# Work Order ID 89858

Item Name: Crosstube Turning Detail

<b>DART AEROSPACE LTD</b>	<b>Work Order:</b>	89858
<b>Description:</b> Crosstube Assembly (205/212/412 Low Fwd)	<b>Part Number:</b>	D212-664-147
<b>Inspection Dwg:</b> D212-664-147 <b>Rev:</b> B		<b>Page 1 of 2</b>

DRAWING NO. D212-664-147	TITLE CROSSTUBE ASS'Y (205 LOW FWD)	REV. B	<b>DART AEROSPACE LTD ENGINEERING ORDER</b>		D.E.O. NO. D212-664-147-B-1	SHEET NO. SHEET 1 OF 1	SCALE NTS
DRAWN <i>q2</i>	CHECKED <i>ASS</i>	MFG. APPR. <i>VB</i>	APPROVED <i>WJ</i>		DE APPR. <i>WJ</i>		
DATE 11.07.15	DATE 11.07.20	DATE 11.07.21	DATE 11/07/21		DATE 11.07.21

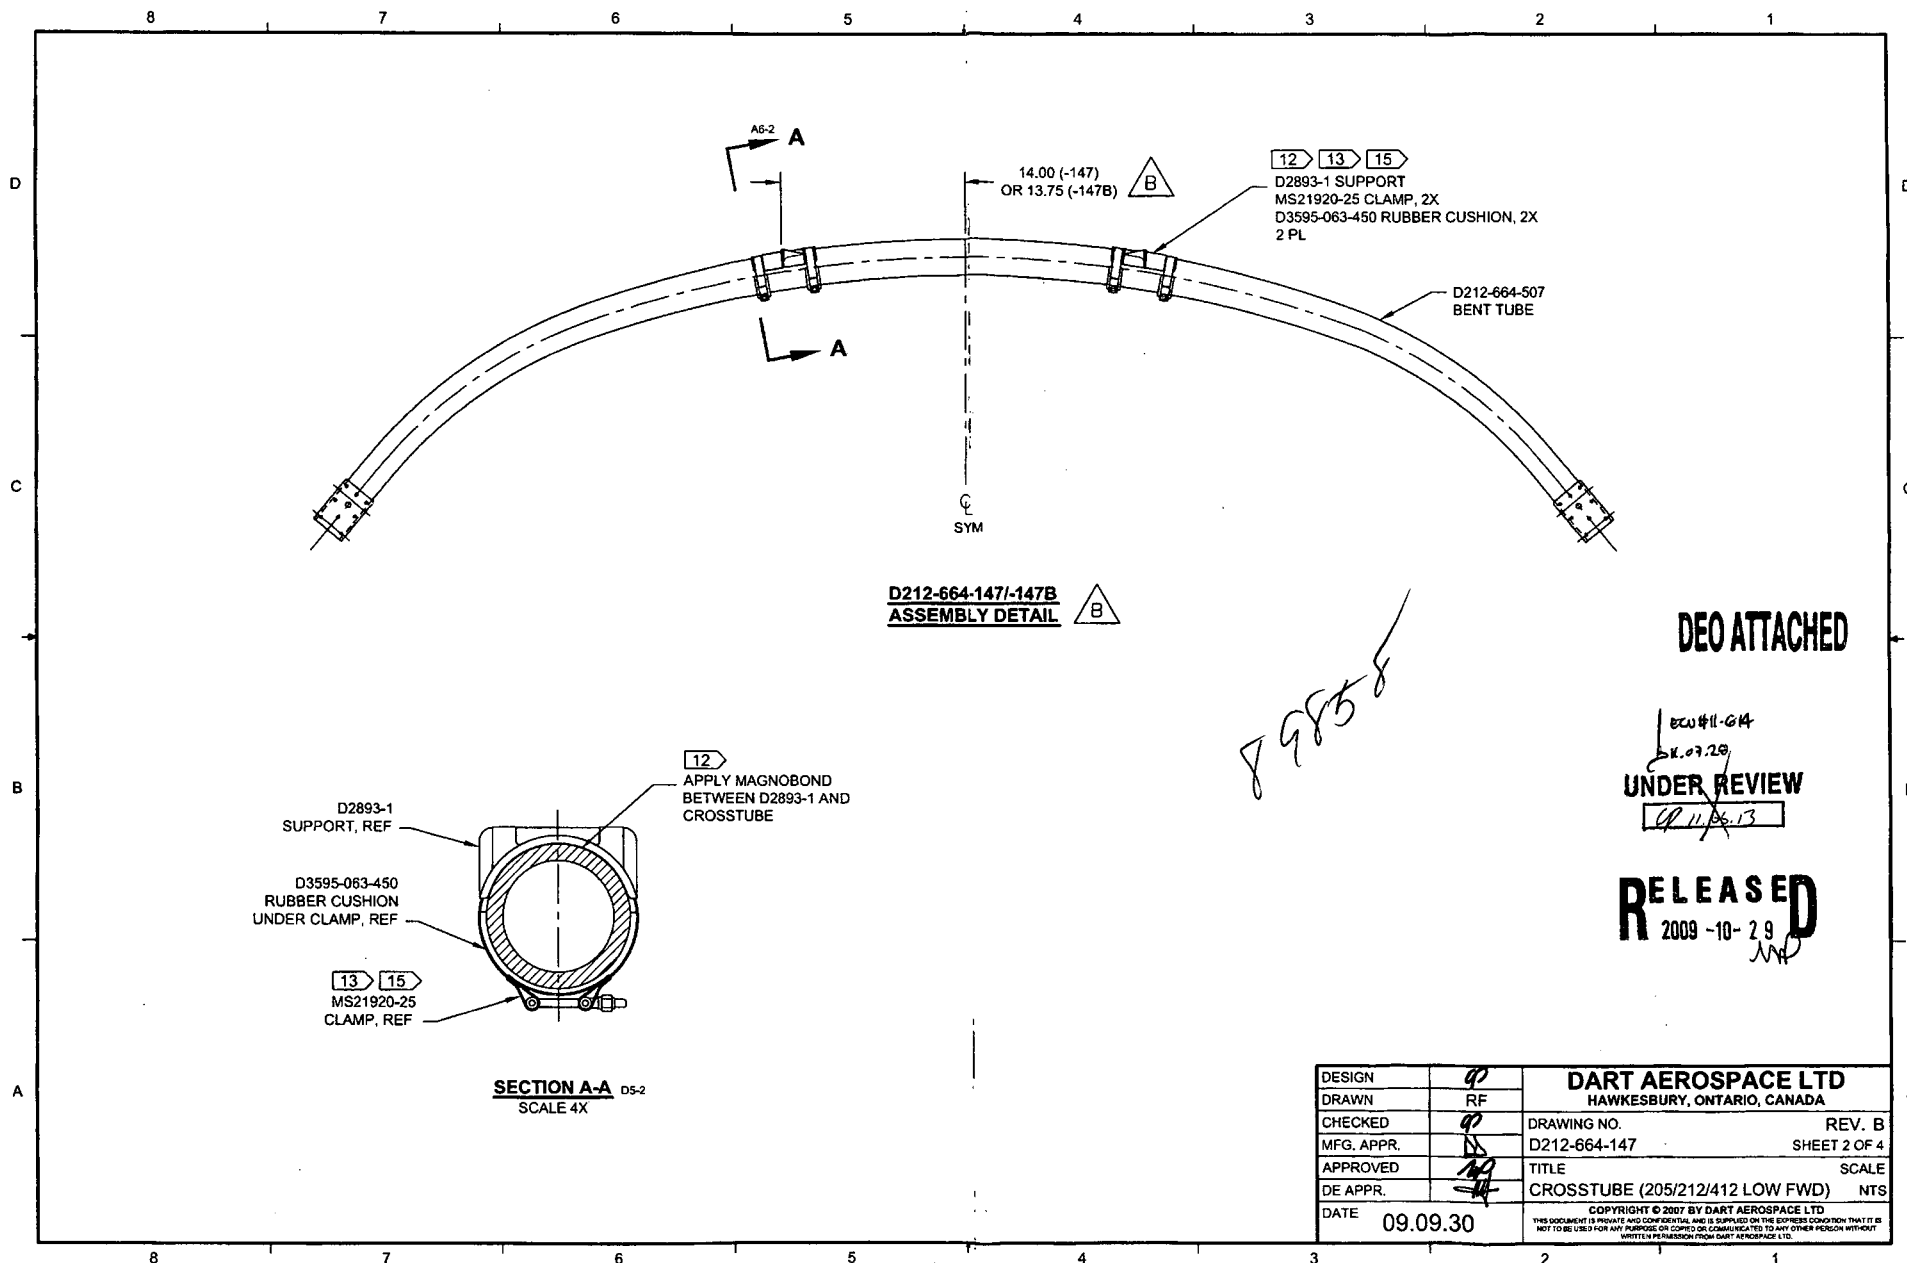
**PURPOSE:**

REPLACE MAGNOBOND WITH PROSEAL.

NOTE 12 & 15, SHEET 1 IS AMENDED AS FOLLOWS:

IS:

Item	Qty -147	Qty -147B	Part Number	Description
9	A/R	A/R	PROSEAL 890 B-2	SEALANT, AMS-S-8802 CLASS B-2

IS:

- 12) TO INSTALL D2893-1 SUPPORT: ABRASE MATING SURFACE OF SUPPORT AND CROSSTUBE WITH 180-GRIT SANDPAPER AND REMOVE RESIDUE WITH MEK (OR EQUIVALENT). APPLY A 0.04" TO 0.07" THICK LAYER OF PROSEAL 890 CLASS B-2 (OR AMS-S-8802 CLASS B-2) SEALANT TO MATING SURFACE OF SUPPORT.
- 15) TORQUE CLAMPS 80 TO 100 IN-LB. ENSURE AT LEAST 1.5 THREADS SHOWING IN SAFETY AND THAT NUT HAS NOT BOTTOMED-OUT AFTER TORQUING. **PRIOR TO PACKAGING, RE-CHECK TORQUE ON CLAMPS AFTER PROSEAL 890 SEALANT HAS CURED FOR 72 HOURS.**
